# Lakestone Phased Development Agreement (PDA)

MACDONALD  
COMMUNITIES LIMITED

Lakestone  
Phased Development  
Agreement (PDA)  
2<sup>nd</sup> Committee of the Whole

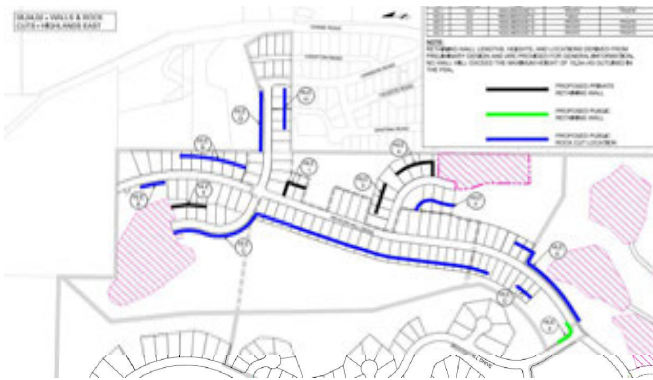
**Concern:** Why are the wall standards set out for Lakestone not being applied District wide?

1. The wall sizes are necessary for Lakestone, so should be left in the PDA.
  2. Concurrently, the DLC is doing a review of its retaining wall policy with the aim to make these rules applicable District wide in areas where applicable / appropriate.
-
